**RE: LSPGC Response to CPUC Data Request #8 for LS Power Grid California, LLC's
Collinsville 500/230 Kilovolt Substation Project (A.24-07-018)**

As requested by the California Public Utilities Commission (CPUC), LS Power Grid California, LLC (LSPGC) has collected and provided the additional information that is needed to continue the environmental review of the Collinsville 500/230 kilovolt (kV) Substation Project (Application 24-07-018). This letter includes the following enclosures:

Figure 1 Alternative 1

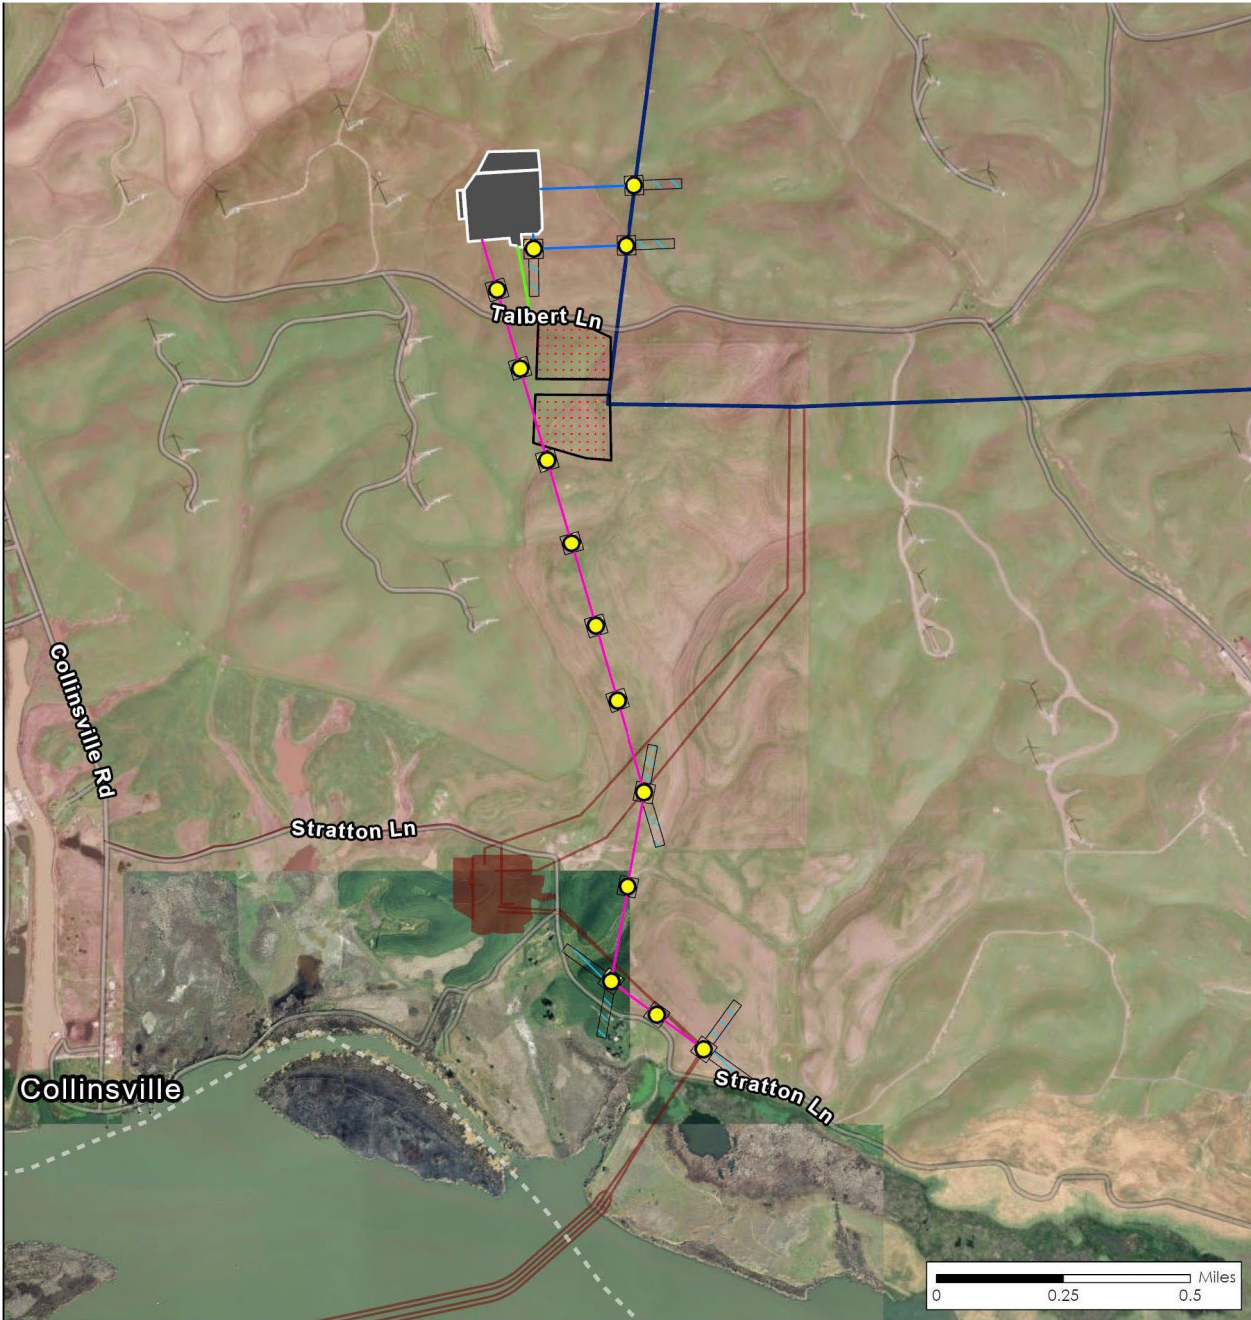
Section/Page Reference	CPUC Comment	Request ID	CPUC Request	LSPGC/PG&E Response
n/a	<p>DR-2: 12 kV Distribution Line for Alternatives 1 and 2</p> <p>The GIS data for Alternatives 1 and 2 include 12 kV distribution lines, but do not include structures for those lines.</p>	2	<p>Please clarify whether the 12 kV line shown in the GIS data for Alternatives 1 and 2 is an existing line or if it will be a newly constructed line. If it is new construction, please provide GIS data for the location of the support structures and confirm that wood poles would be used for the structures. If the 12kV distribution line would be buried please clarify the depth of burial and dimensions of the trench and provide a typical detail for the buried conduit.</p>	<p>LSPGC: The 12 kV line indicated in the GIS data for Alternatives 1 and 2 will be newly constructed. Attachment A provides support structure locations. The wood poles will be approximately 40 feet in height, with diameters of three to four feet, and will be embedded six to ten feet deep.</p> <p>PG&E: Appears reasonable.</p>
